**FRONT END ACCESSORY DRIVE (FEAD) BELT—
BELT NOISE, DAMAGE, AND/OR BELT COMES OFF—
VEHICLES WITH 4.6L ENGINE AND MANUAL
TRANSMISSION**

**Article No.
98-20-18**

FORD: 1996-1998 MUSTANG

Figure 1 - Article 98-20-18

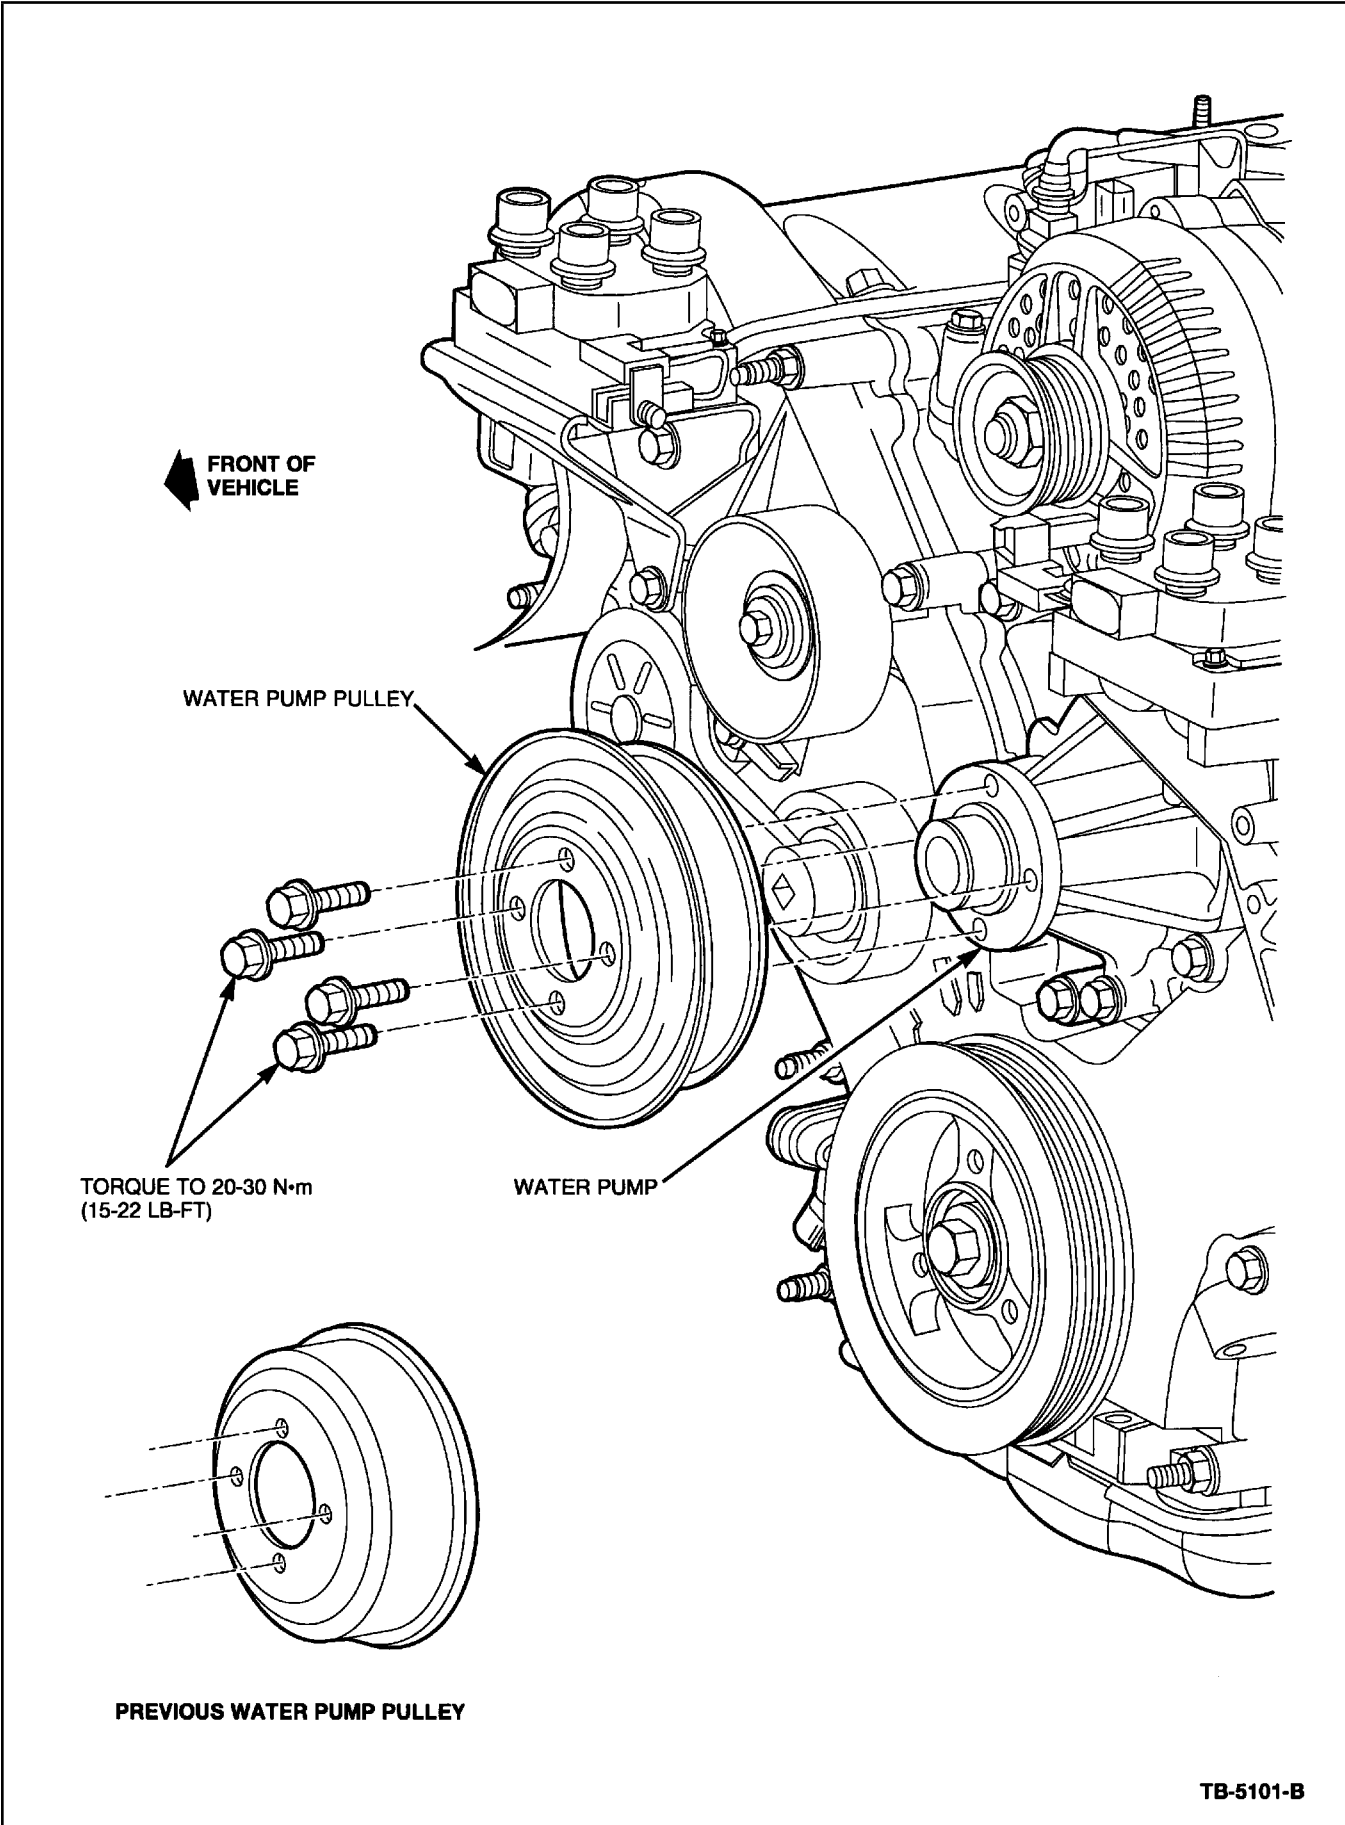
1. Remove FEAD belt and discard.
2. Verify that the vehicle has the new flanged water pump pulley installed (Figure 1). If raised flange pulley is not installed, remove and discard water pump pulley. Install new Water Pump Pulley (F6ZZ-8509-AA) and torque bolts to 20-30 N•m (15-22 lb-ft).

Figure 2 - Article 98-20-18

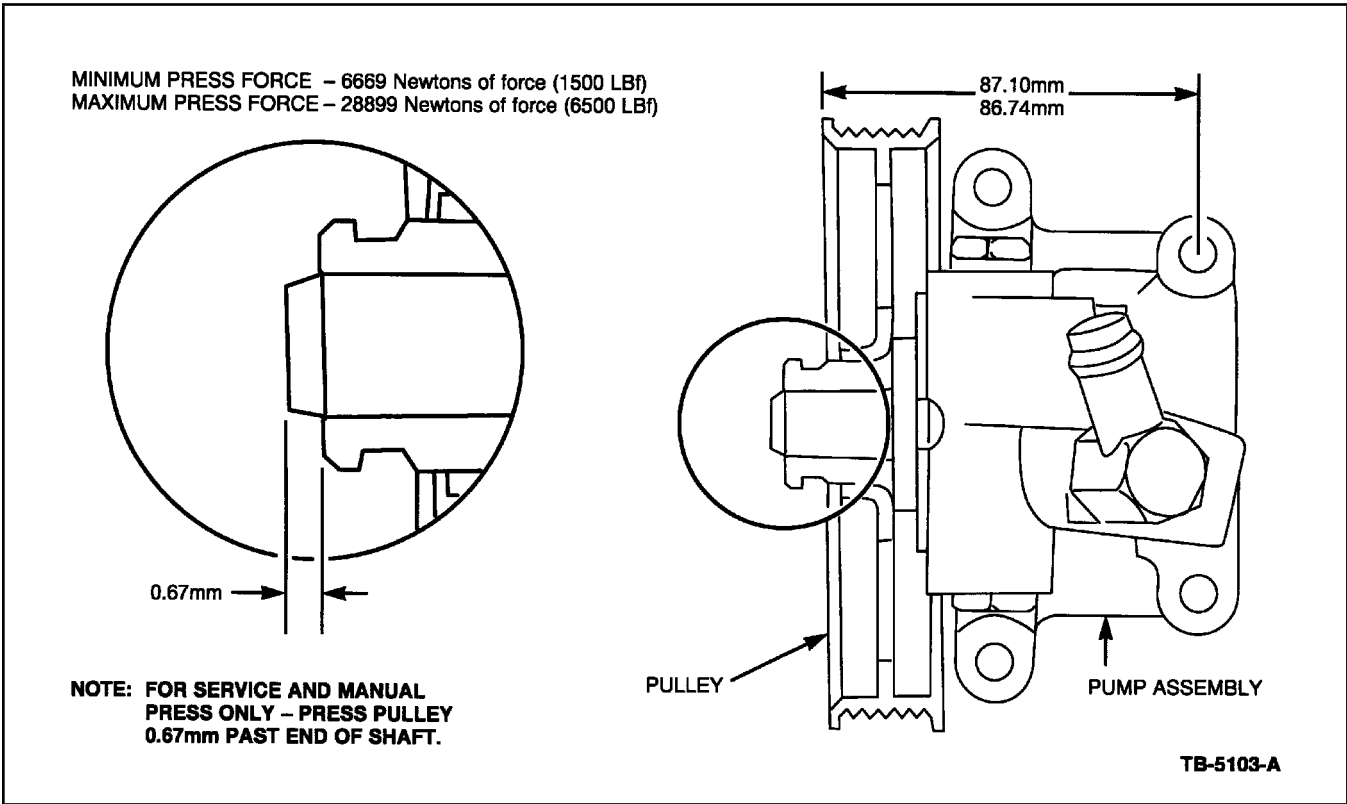
THE POWER STEERING PULLEY MUST BE PRESSED ON 0.67mm PAST THE END OF THE SHAFT (FIGURE 2).

Figure 3 - Article 98-20-18

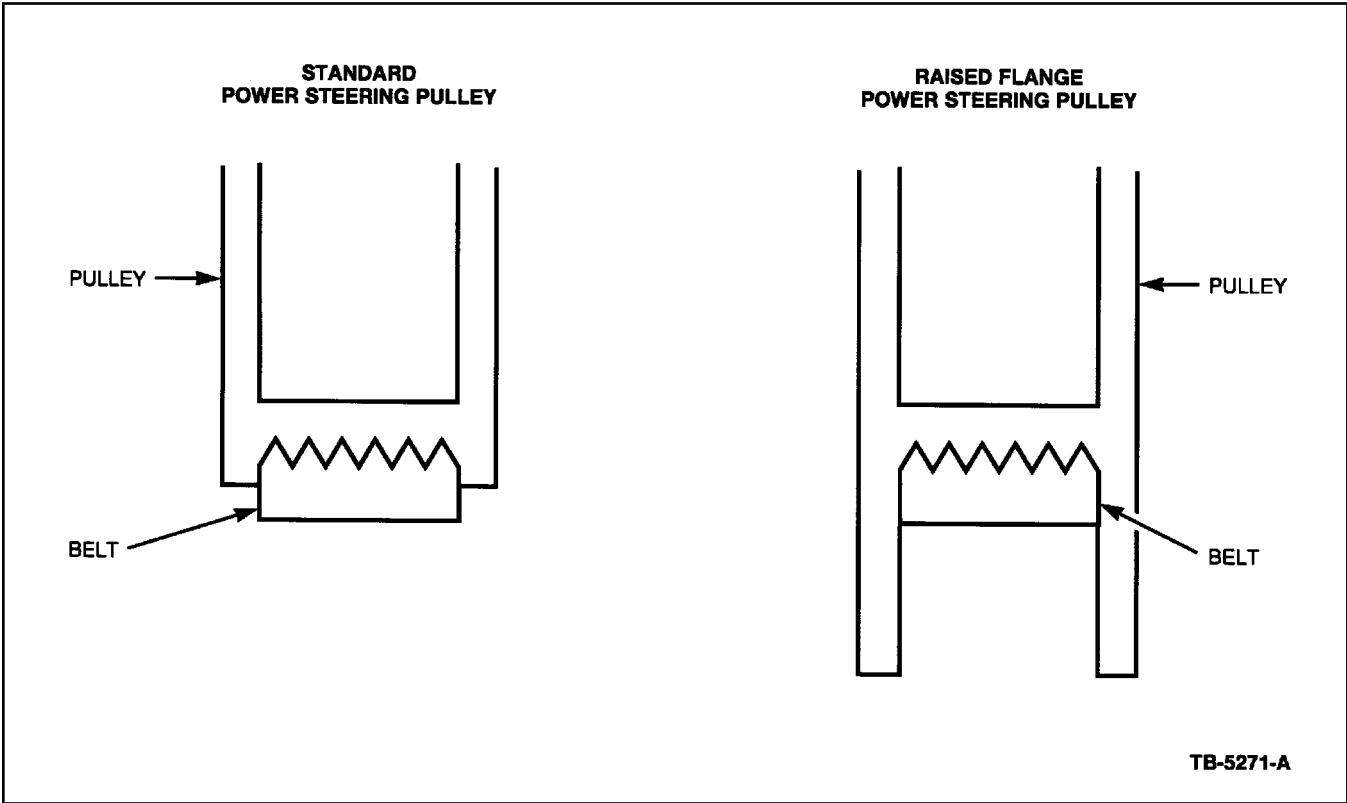
3. Verify that the vehicle has the new power steering pulley installed (Figure 3). If raised flange pulley is not installed, remove and discard the power steering pulley. Install new Power Steering Pulley (F7ZZ-3A733-AA).
4. On the bottom of the power steering pump there is a power steering line orientation clip that is mounted with a single fastener. Remove and discard the clip. Install the replacement Power Steering Orientation Clip (F7ZZ-3E523-AA).

Figure 5 - Article 98-20-18

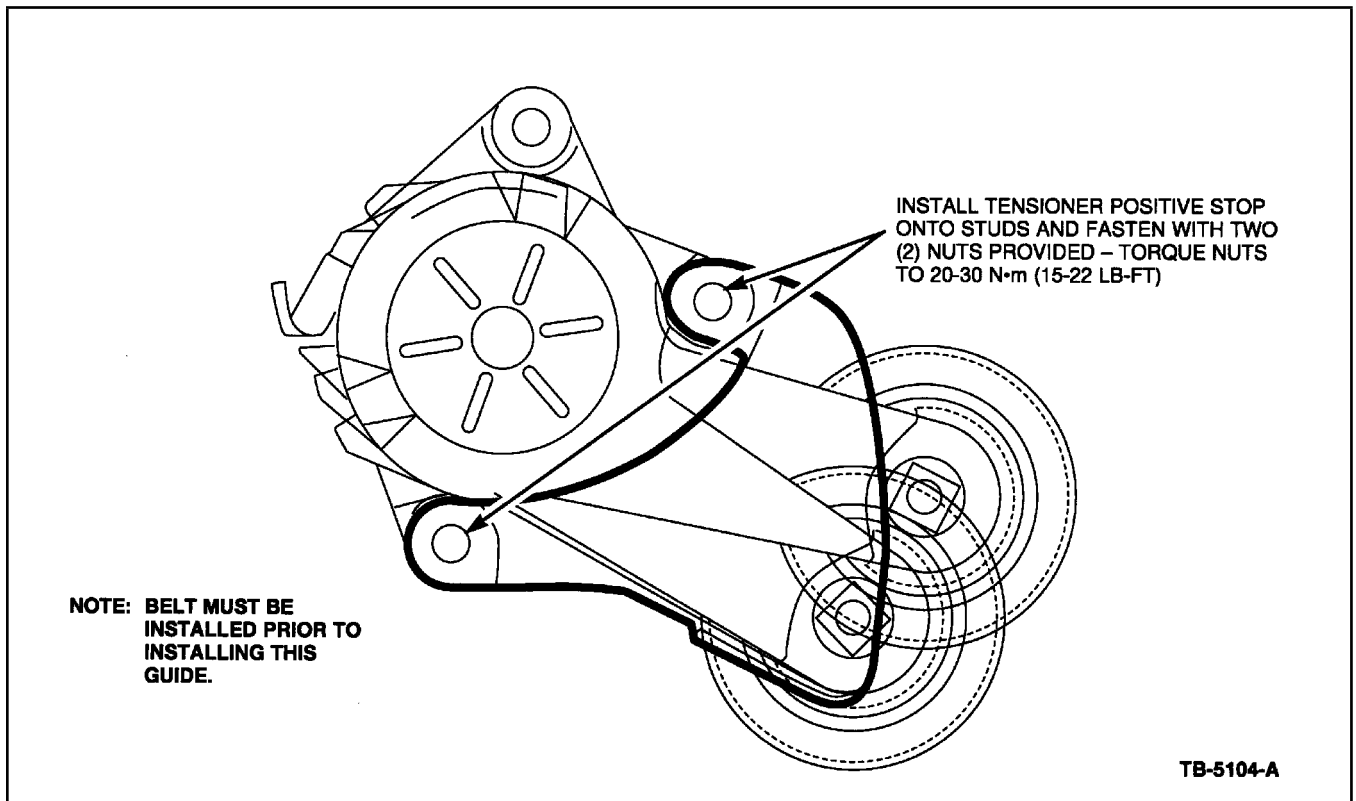
5. Locate the automatic belt tensioner. If a tensioner positive stop is installed over the tensioner and the part number stamped on the bottom of the positive stop is F7ZE-19A439-AB, remove and discard the positive stop and belt tensioner.
6. If the positive tensioner stop was not installed on the vehicle, remove the three (3) fasteners that mount the automatic belt tensioner. Retain the nut. Discard the tensioner, belt guide and both bolts (Figure 4).
7. Install the new steel Tensioner (F8ZZ-6B209-BA) using one (1) existing stud and two (2) new Studs (N807336-S2) (Figure 5). Torque the studs and nuts to 20-30 N•m (15-22 lb-ft).
8. Install a new FEAD Belt (F8AZ-8620-AA).
9. Install the Tensioner Positive Stop (F7ZZ-19A439-AC) onto the two (2) studs that mount the tensioner (Figure 5). Fasten the stop bracket with two (2) Nuts (N804178-S309). Torque the nuts to 20-30 N•m (15-22 lb-ft).
